.....  
Velcon Filters, Inc.

# Service Bulletin

June 7, 2005

## Blind Cap Assembly PN 60464

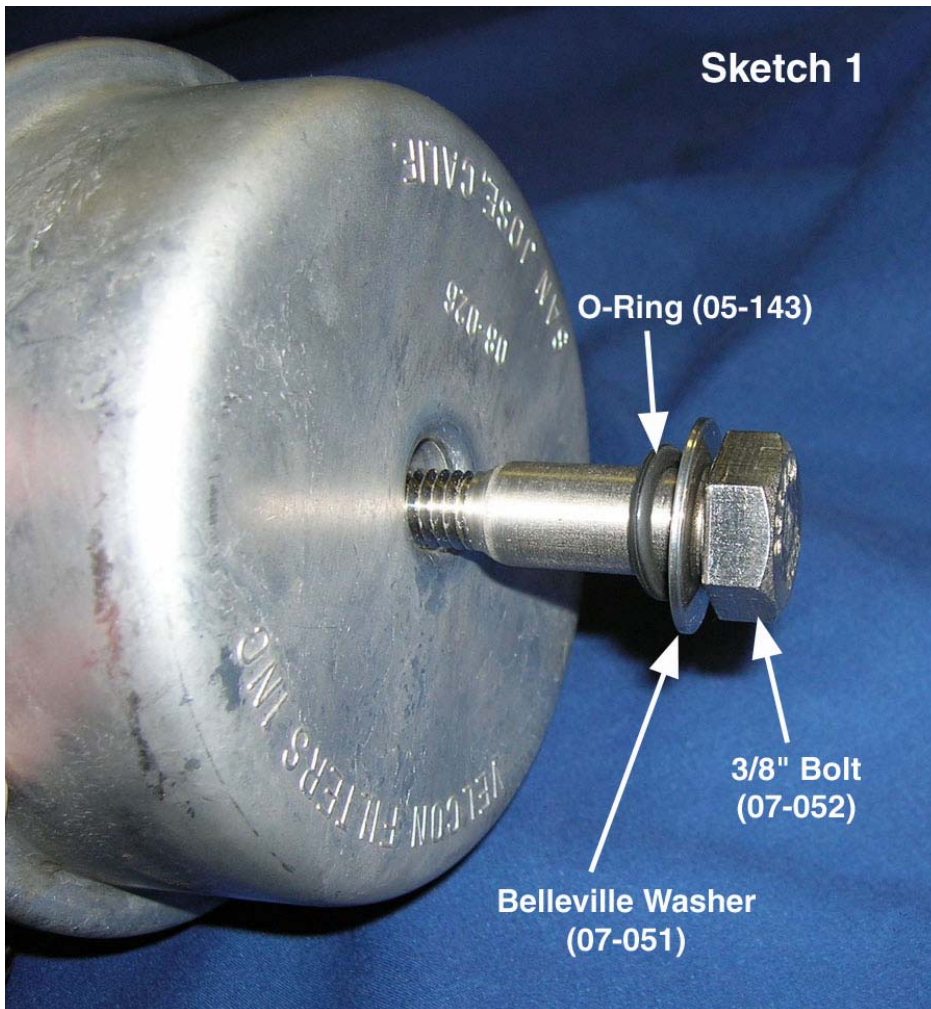
During a recent change out leakage was observed around the flat gasket (Velcon PN G-0313). We are recommending at the next change-out, or per your company's QC/fuel quality recommendation, a change to the bolt assembly.

Please see Sketch 1 that shows a new bolt (PN 07-052) to replace the one used with 3/8" bulk head threads.

In Velcon vessels, replace the existing bolt, gasket, flat washer and lock washer with a 3/8 inch bolt (PN 07-052), a Belleville (spring) washer (PN 07-051), and O-ring (PN 05-143). In Facet/Fram vessels, reuse the existing bolt and replace the remaining hardware with a Belleville (spring) washer (PN 07-051) and an O-ring (PN 05-143). **With these arrangements, the torque rating is 15 ft-lbs.**

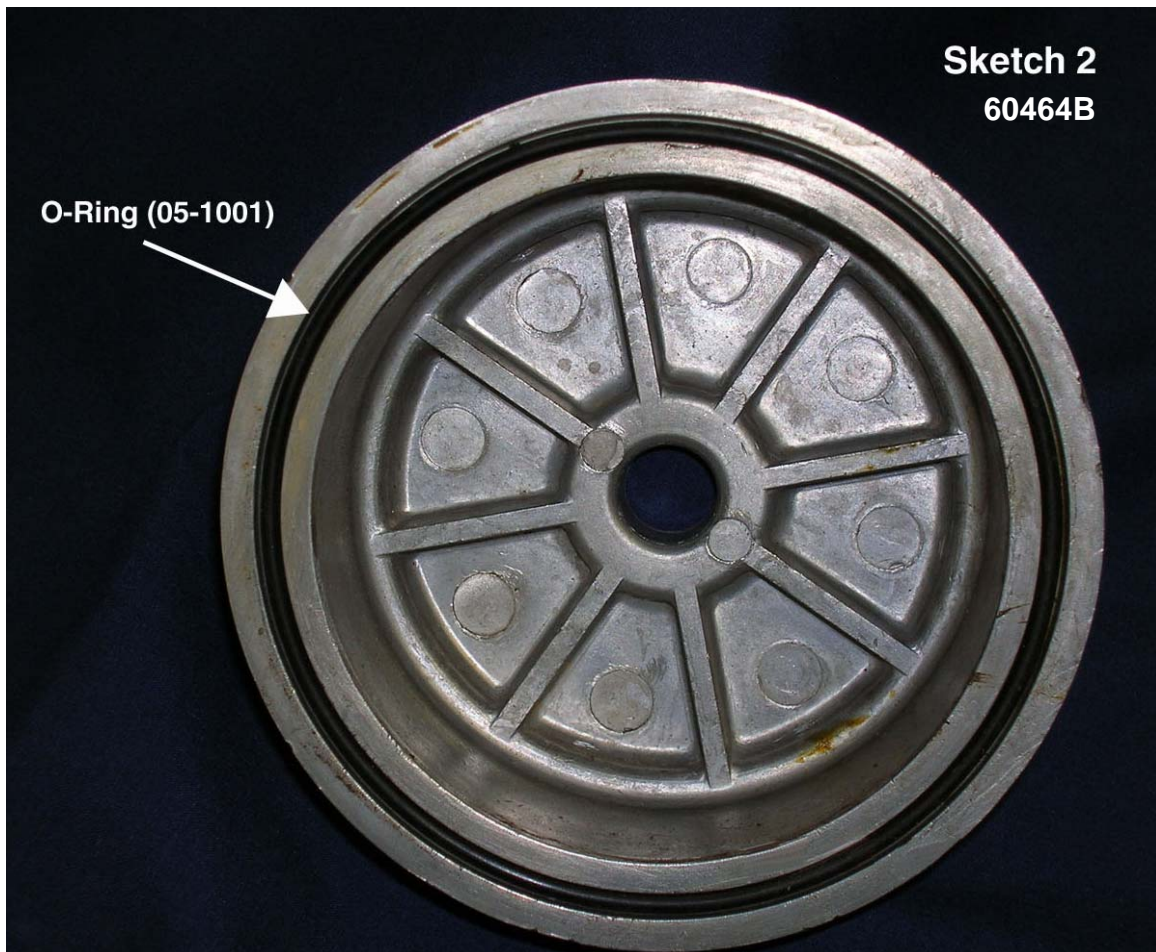
If the blind cap assembly is fitted to a flat surface with no knife edge and the pressure after the filter vessel exceeds 110 psi then we recommend using an O-ring seal (PN 05-1001) as shown in Sketch 2. (Use care to make sure the O-ring does not fall out when fitting it to the surface.)

The complete assembly with o-ring seal would be PN 60464B.
